Subject: MHI's Response to US-APWR DCD RAI No. 322-1999 (45-day response)

Response to Request for Additional Information No. 322-1999,
Revision 0 (45-day response)

US-APWR Design Certification

RAI NO.: NO. 322-1999 REVISION 0

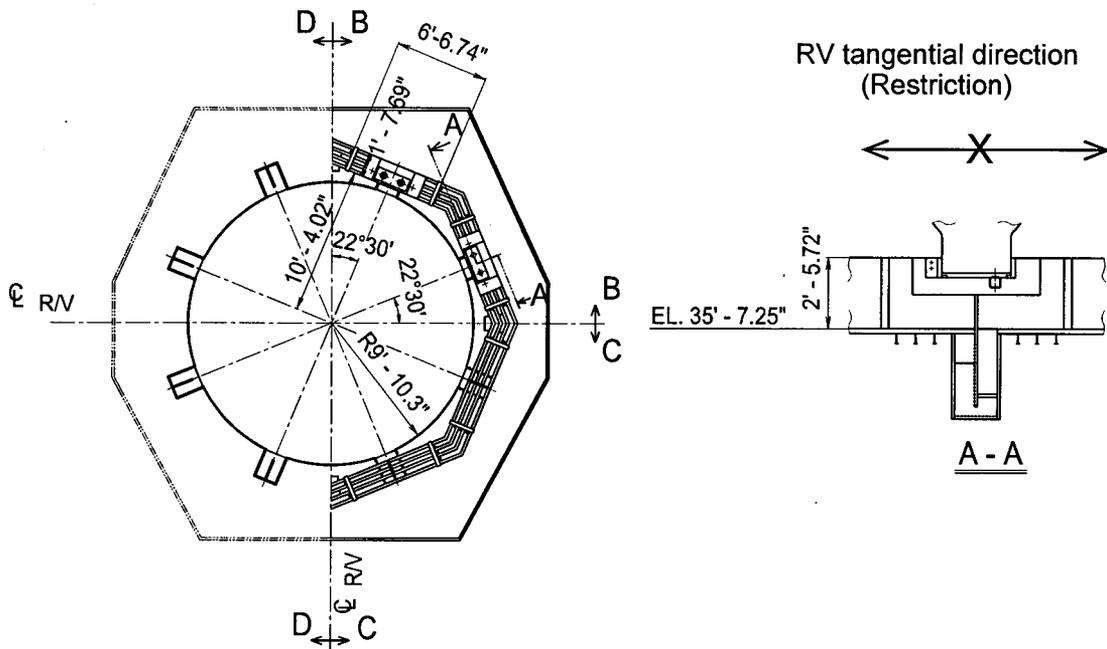
- (b) Describe how the control of the horizontal load through the support brackets and the base plate is accomplished such that the vessel position is unchanged while allowing radial thermal growth.
- (c) How is the RV modeled in the seismic analysis? Was the rocking mode of vibration of the RV included in the model?

- (a) The sliding support pads and shim plates are made of metallic materials only. No non-metallic materials will be used for sliding support pads.
- (b) The Reactor Vessel (RV) supports of US-APWR are located at the RV outlet and inlet nozzles, eight locations as shown in figure below. The RV support allows radial displacement of the RV, but does not allow tangential displacement of the RV, as shown in section A-A of the figure. When a horizontal load acts on the RV, the RV support in the tangential direction of the RV will restrict the displacement of the RV.

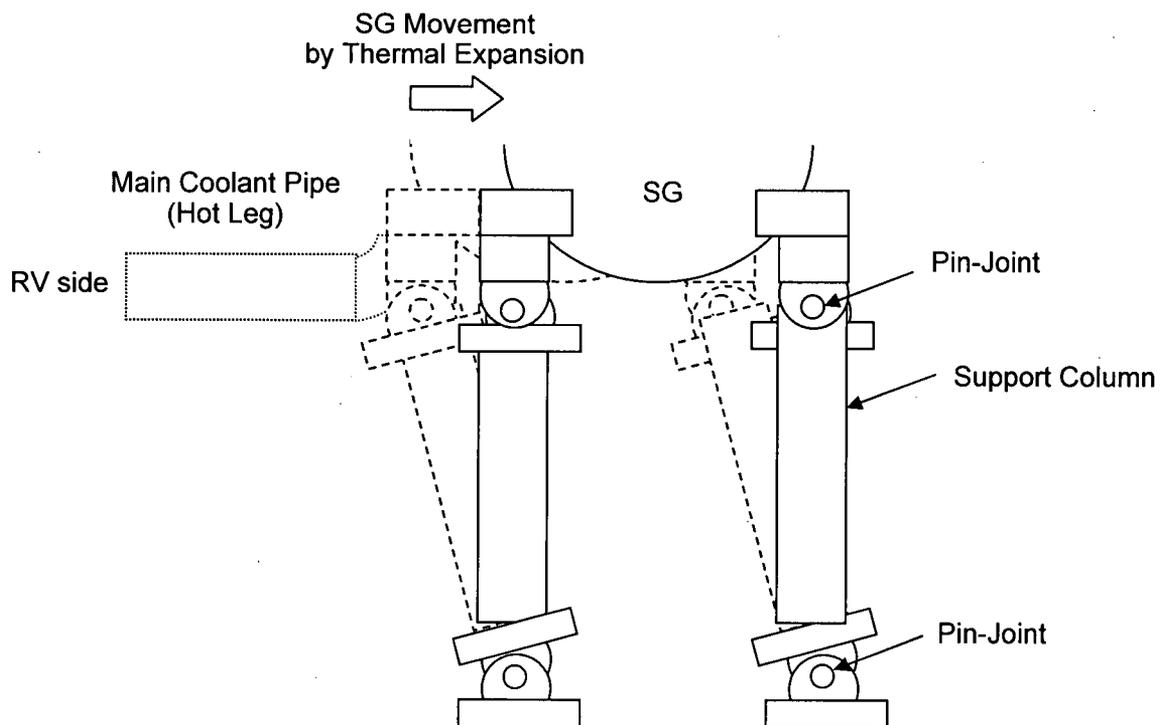
- (a) Provide the rationale for selecting the number and location of the lateral supports for the steam generators.
 - (b) Use of a pin-joint allows free rotation but does not allow displacement to take place. Provide information that shows clearly how the pin-joints permit movement of the SG caused by thermal expansion of piping that is attached to the SG.
-

- (b) The support columns of steam generator will be set up considering the thermal expansion movement of the hot leg and SG that is calculating at 100% power operation. The upper end pin-joint of the support columns toward the lower end pin-joint of support columns will be set to the position based on calculated thermal expansion caused by hot leg and the SG-to-hot leg direction. Therefore, support columns will be set to tilt to the RV side slightly, the set of support column pin-joints, upper and lower, will not restrict thermal expansion displacement of SG as shown in figure below.

Figure 3.8.3-7 Typical Details of SC Modules
(Sheet 2 of 5)

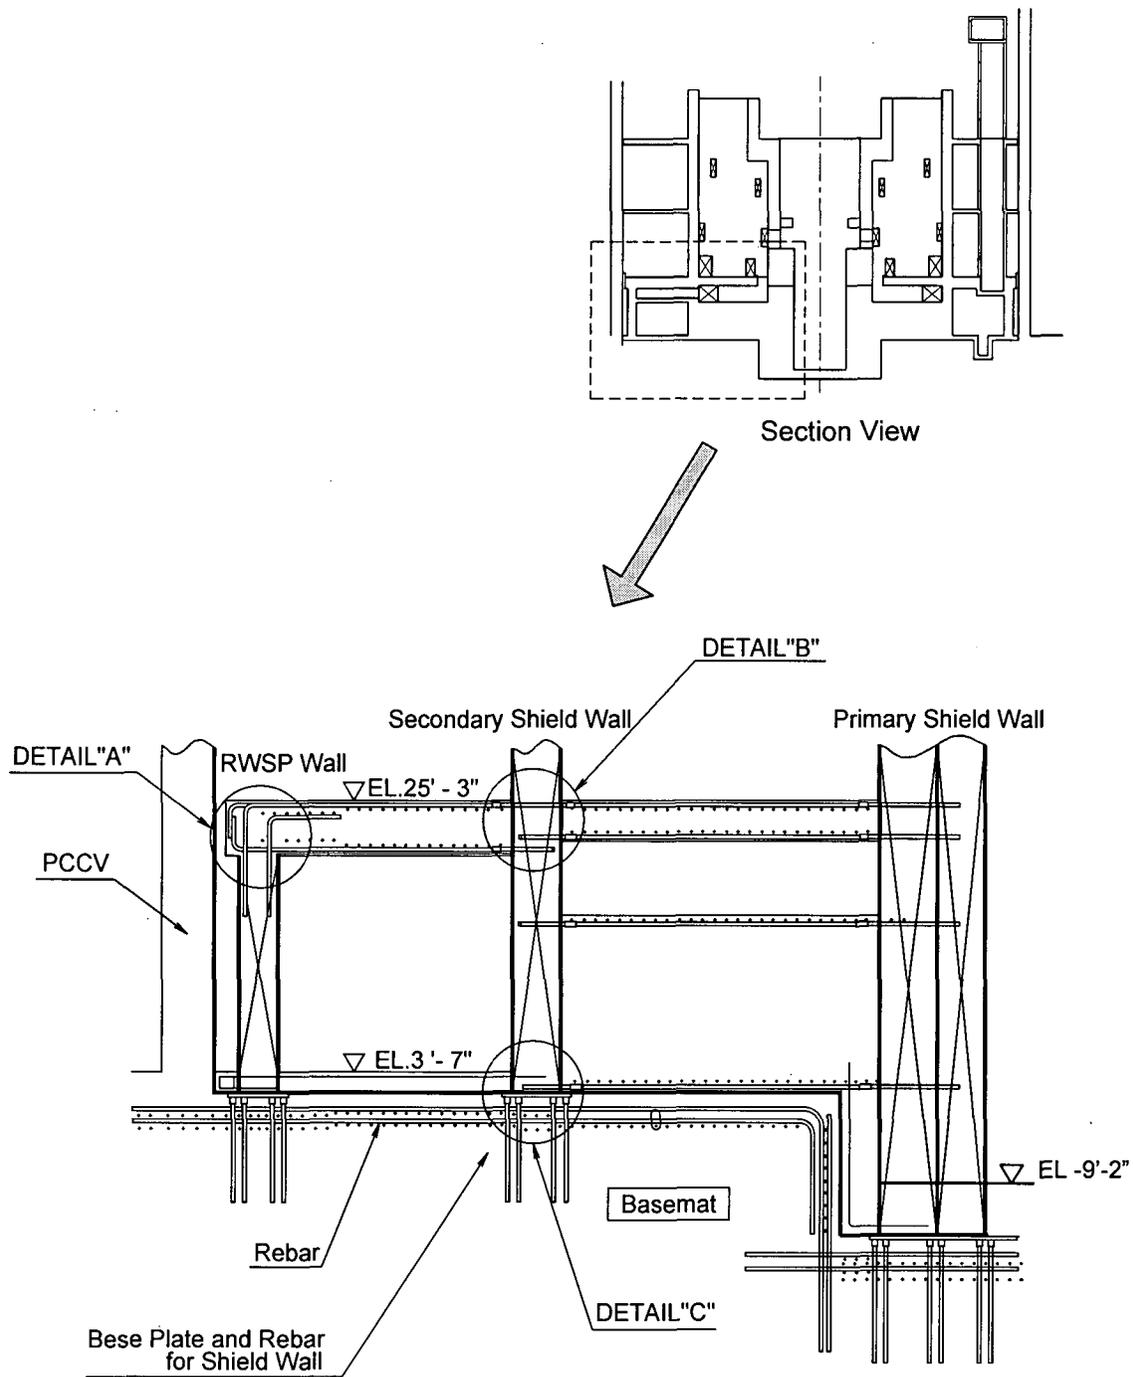
In Sheet 2 of 5 of DCD Figure 3.8.3-7 (Page 3.8-185), the elevation of 9'-2" marked on the structure is lower than the mark on the structure for the elevation of 3'-7".

The applicant is requested to provide clarification, or correct this apparent error.

The correct elevation should be -9'-2".

- Change Figure 3.8.3-7 (Rev. 1, page 3.8-185) to read: "-9'-2"
